JOINT REGIONAL PLANNING PANEL

DEVELOPMENT ASSESSMENT REPORT

2 APRIL 2015

Application No.	D/2014/646
Address	30-40 George Street, LEICHHARDT NSW 2040
Proposal	Site preparation works (including diversion of services, demolition of existing structures and excavation), construction of 2 buildings of between 4 and 8 storeys comprising 123 residential units above a 2 level basement car park with 122 parking spaces, and associated works including providing communal open space incorporating a pool, landscaping works, removal of trees, provision of roof gardens with plunge pools, and strata subdivision
Date of Receipt	28 November 2014
Applicant	Stithos Pty Ltd
Owner	Mr T D Rowney
Number of Submissions	116 in opposition
Building Classification	Class 7a, Class 2
Main Issues	<ul style="list-style-type: none">• Contamination and inadequate Remediation Action Plan• Adverse streetscape and poor design outcomes• Excessive and inappropriate scale• Inadequate deep soil zone / landscaping across the site and unsatisfactory public through-site link design• Poor amenity outcomes on the site• Adverse amenity impacts on adjoining properties• Unsatisfactory basement design, including unresolved waste m

Figure 4: Southern side of development

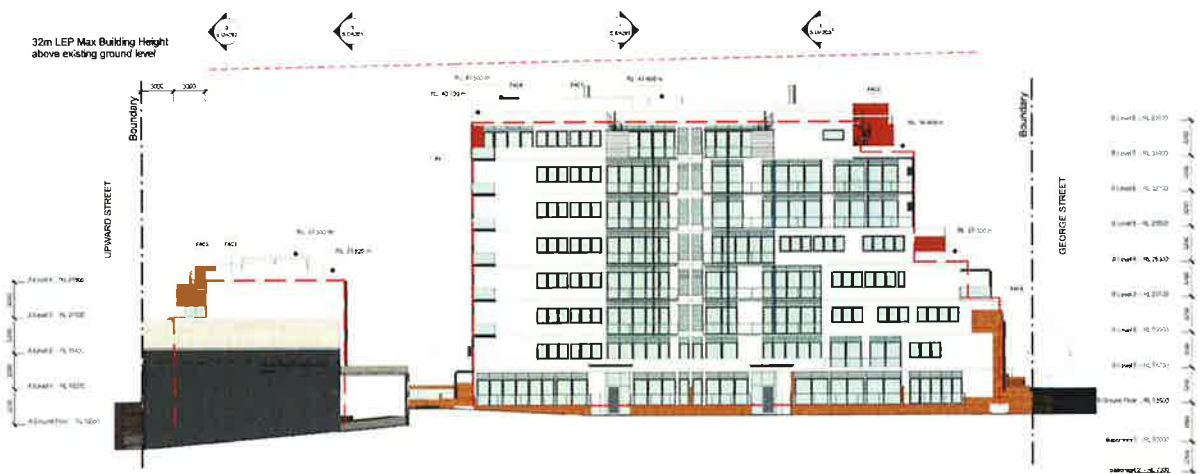
While both buildings will not exceed the maximum height / number of storeys controls prescribed by the site specific controls, concerns are raised regarding the overall form,

bulk and massing of the development generally, which when combined with other concerns relating to building design, will result in a proposal that will have unsatisfactory streetscape impacts and that will be a poor response to its context. More specifically, the following scale concerns are particularly raised:

When all the above factors are combined, there are general public domain scale concerns, particularly as viewed to the south of the site on George Street, and a general failure to provide an appropriate transition to adjacent lower built scales, including to the adjacent Kolotex proposal (on George Street). In summary, the proposal is generally of an excessive and unacceptable scale and does not satisfy this principle.
